RATTLE NOISE FROM THE FRONT SUSPENSION WHILE DRIVING THE VEHICLE

Bulletin No.: 02-003/24

Last Issued : 08/23/2024

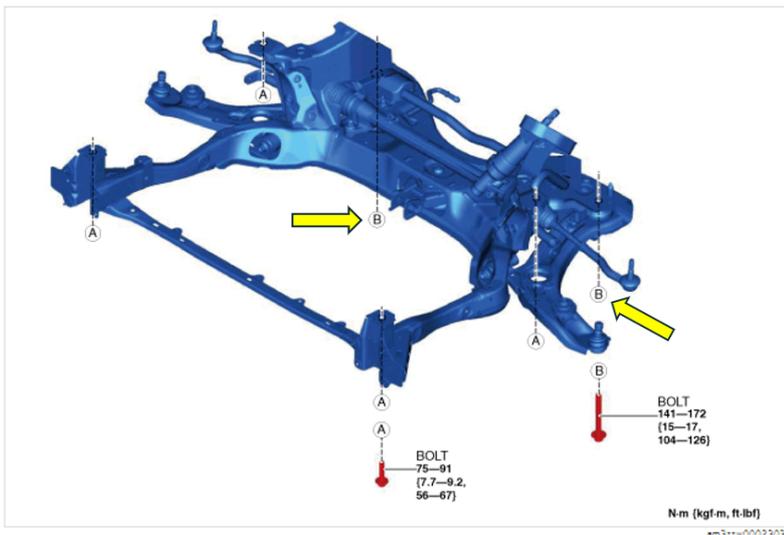
Some customers may experience a rattle noise coming from the front suspension while driving the vehicle, with no other driveability concerns. The rattle noise may be caused by a decrease in tightening torque of the two (2) front lower control arm bolts (B) shown in the image below.

The decrease in bolt tightening torque is due to corrosion formation at the bolt head. After the bolt head is weakened, it will most likely become separated from the rest of the bolt. However, this is not a safety concern as the other suspension bolts will remain intact. To eliminate this rattle noise concern, the bolt quality has been improved and a soft metal washer has been used to further prevent corrosion formation.

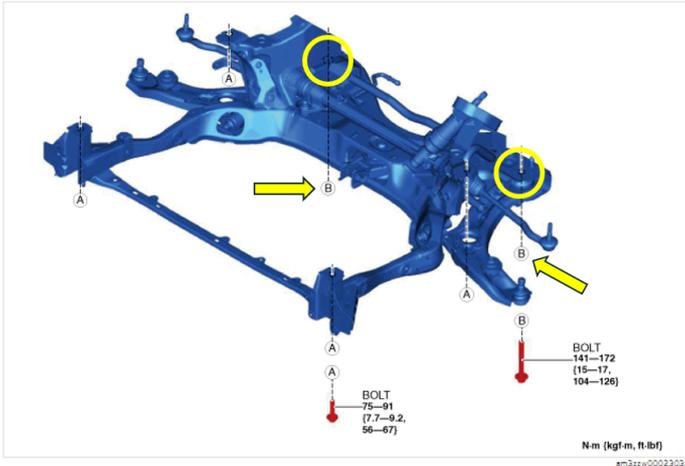
2. Remove both left and right side front suspension bolts (B).

- If the "B" bolts cannot be gripped/removed with the subframe in place, it may be necessary to remove the "A" bolts to lower the subframe to create enough space to unscrew the "B" bolt studs with needle-nose pliers.
- If the "A" bolts are removed to lower the subframe, they must be re-torqued in place before loosening the opposite side "A" bolts.

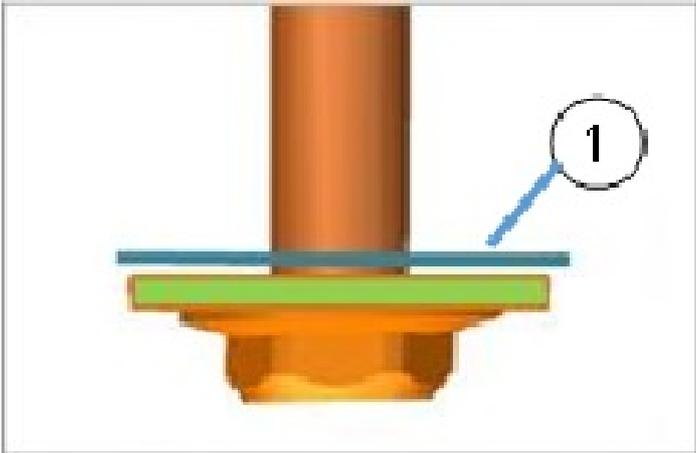
4. Install both new bolts (B) including a soft metal washer (1).

NOTE: The soft washer (1) is a critical component for repair durability and should not be omitted.

Tightening Torque: Nm 141-172 (kgf-m 15-17, ft-lbf 104-126)
